UKPCS-003

Approval Drawings

ICF general arrangements, steel over ICF, elevations, sections

Icf Homes - Dendrons

GF ICF GENERAL ARRANGEMENT

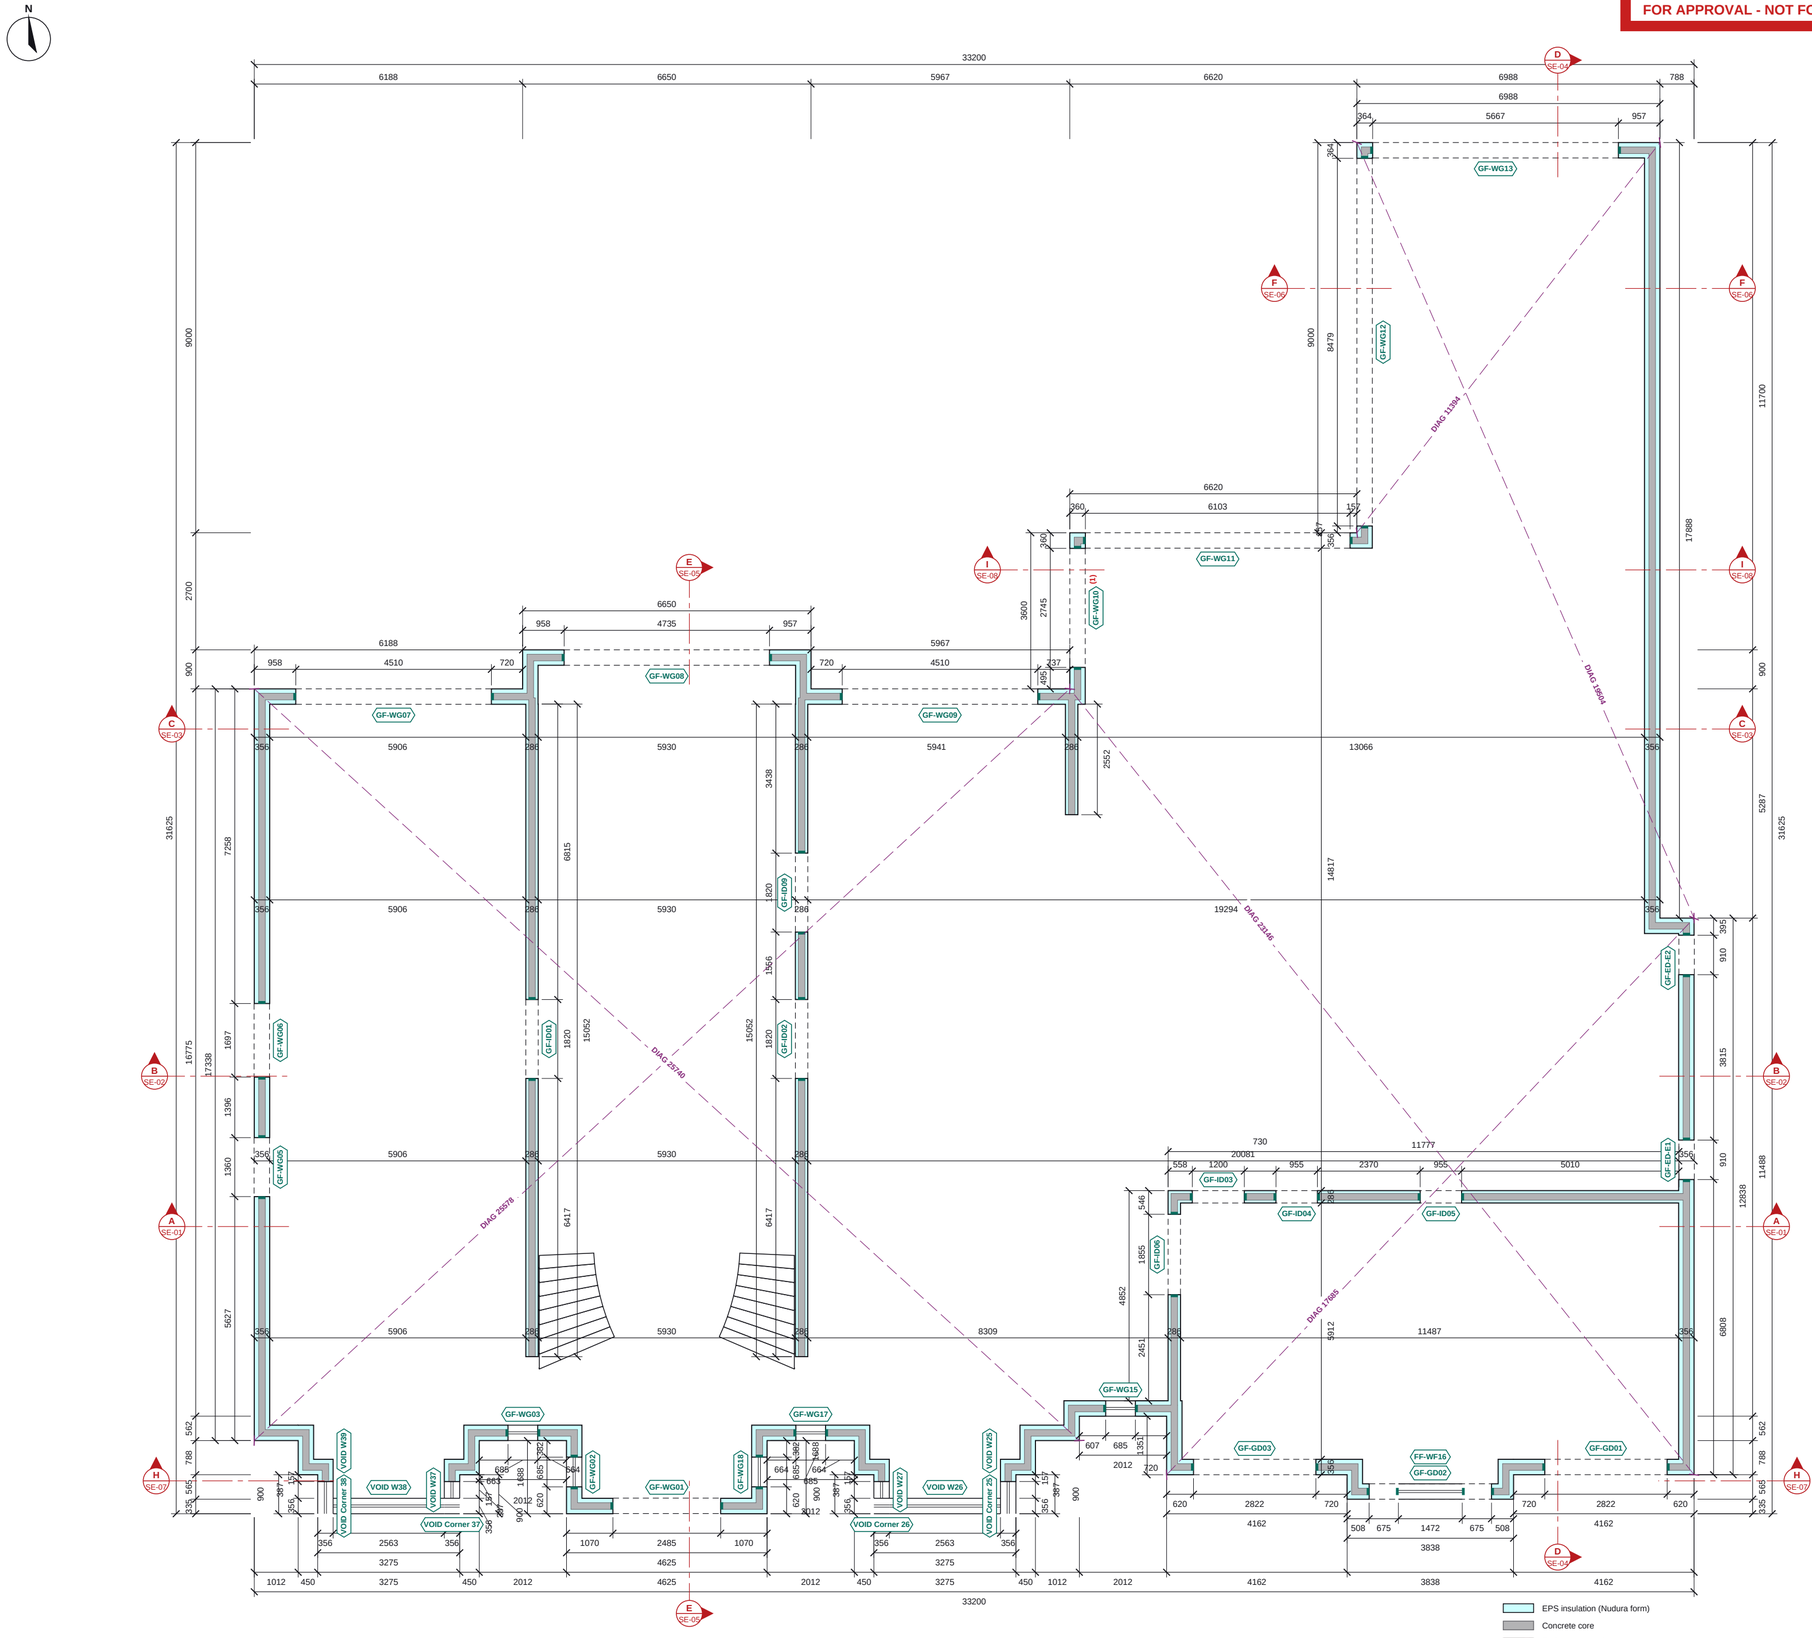
1. P03 revises the P02 approval issue (16.10.26) to Chris Yeates' comments of 16.10.26 and his opening schedule: GF internal door heads 2700, FF-ID01/02 heads 5850, FF-WF01 sill 3900 / head 6150, the north bay screen sill dropped to +3425 with its arch raised 75 mm, and the first-floor void W7 made an opening (3350-5850) with an ICF lintel.

2. GF-WG10 to WG13 and the GF bay windows: frame heads at 2825. The ICF starts on the steel above; the outer ICF insulation skin is carried down over the steel and the slab edge to the frame head.

Structural openings in the ICF; sill and head above GF FFL. (1) GF-WG10: frame head 2825; ICF starts on the steel, outer ICF skin carried down over the steel and slab edge to the frame head (also WG11-13 and the GF bay voids) VOID = subtract cut in the ICF (no end caps / lintel buck modelled).

NORTH ELEVATION

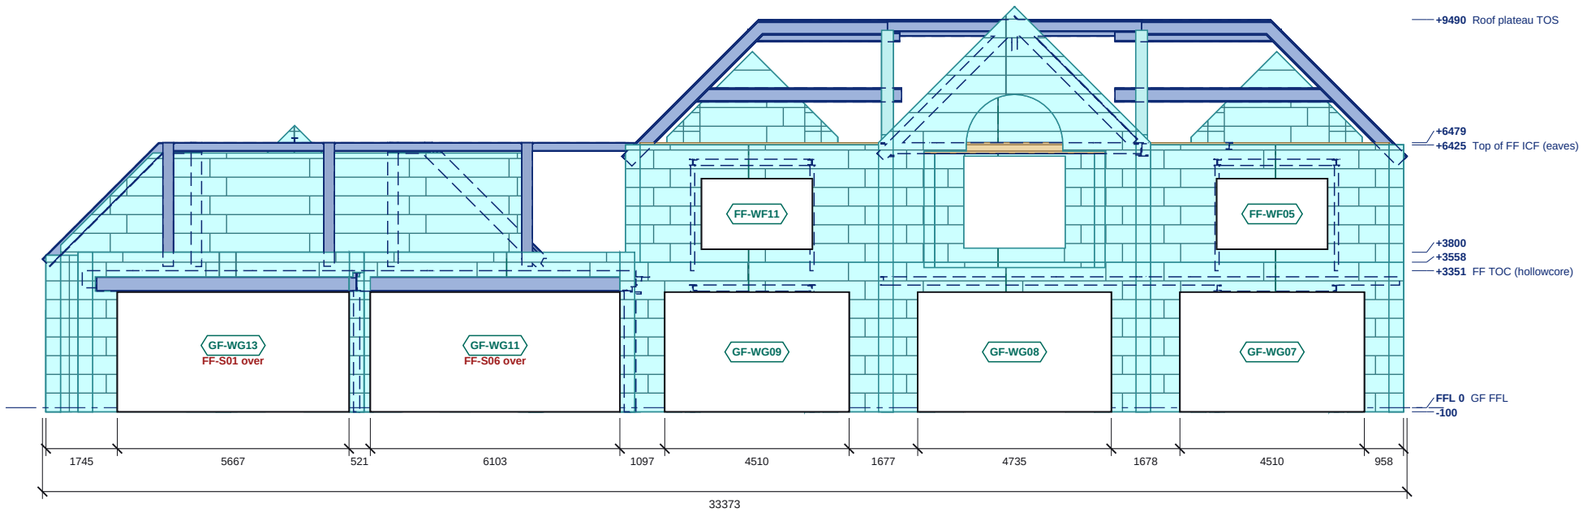
3. The "+3558" level on the P02 elevations was the north bay sill step at the GF/FF ICF joint; it no longer applies.
4. Steel members are re-sized to the architect's 16.10 schedule. Members on that schedule that are not yet modelled (RF-S29, S30, S35, S36, S37 a/b, RF-S40/41, FF-S05/S11/S50/S51, SF-P01/02/05/06) and SF-S02 are awaiting the engineer's revised drawings. Steel is shown for coordination; pockets are site-cut to the pocket schedule.
